Environmental Planning Commission

Agenda Number: 02
Project Number: 1000771
Case #: 16EPC-40007
June 9, 2016

Staff Report

Agent	RBA Architects
Applicant	Brad Allen
Request	Site Development for Building Permit
Legal Description	Tract C Cottonwood Pointe
Location	Between Irving Boulevard and Eagle Ranch Road, south of the Calabacillas arroyo
Size	7 acres
Existing Zoning	SU-1 for I-P, C-2 and R-2 uses
Proposed Zoning	Same

EAGLE RANCH RETAIL
OVERALL ARCHITECTURAL SITE PLAN
ALBUQUERQUE, NEW MEXICO
PROJECT #1555

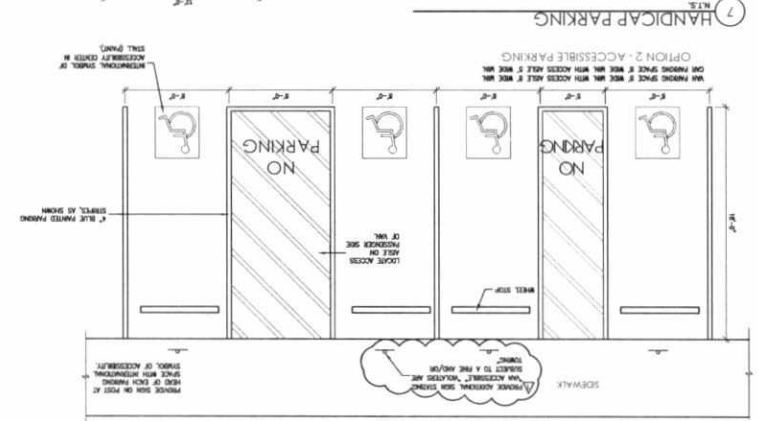
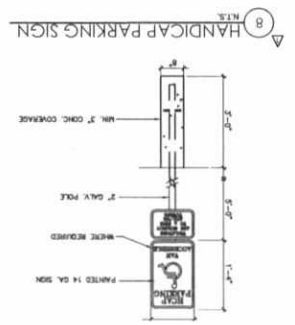
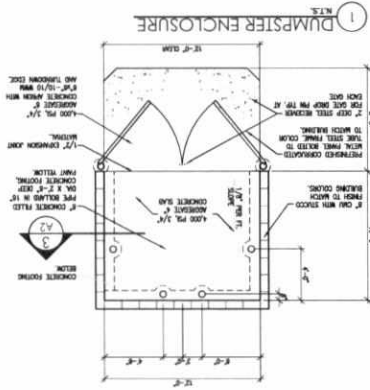
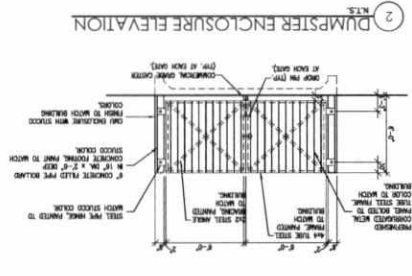
2. Prior to application submittal to the DRB, the applicant shall meet with the staff planner to ensure that all conditions of approval are met.
3. Clarify 141 vs 142 parking spaces shown on sheet AS-1.0.

4. Add a note to sheet AS-1.0 stating that future signage is subject to the requirements of the Coors Corridor Plan and the Site Development Plan for Subdivision

EQUALE RANCH RETAIL
IMD ELEVATIONS
ALBUQUERQUE, NEW MEXICO
PROJECT 8888

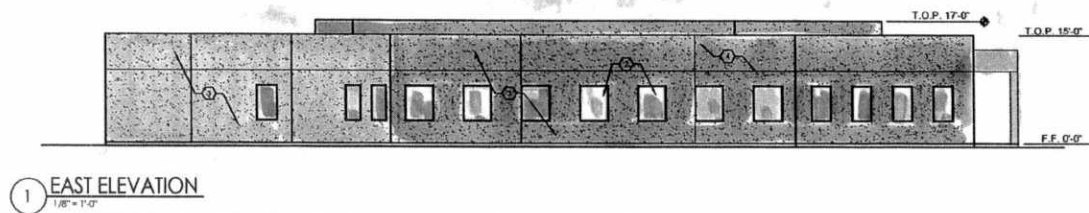
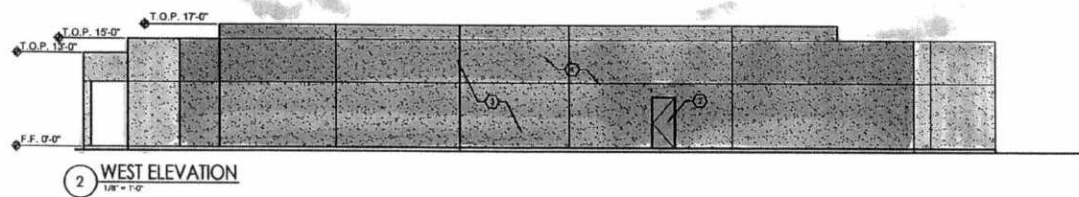
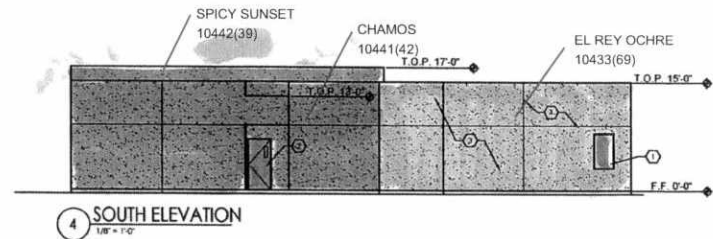
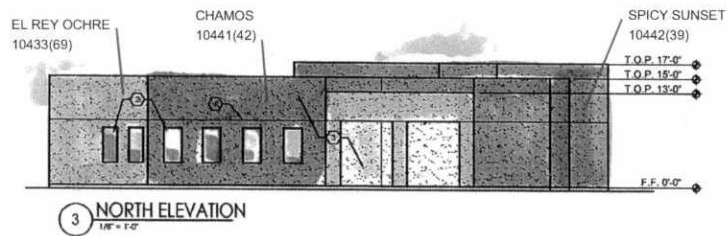
5. The metal accents shall be matte finish and not high reflective to comply with the Coors Corridor Plan.
6. Remove references to health club from grading and drainage and landscaping plans prior to DRB submittal.
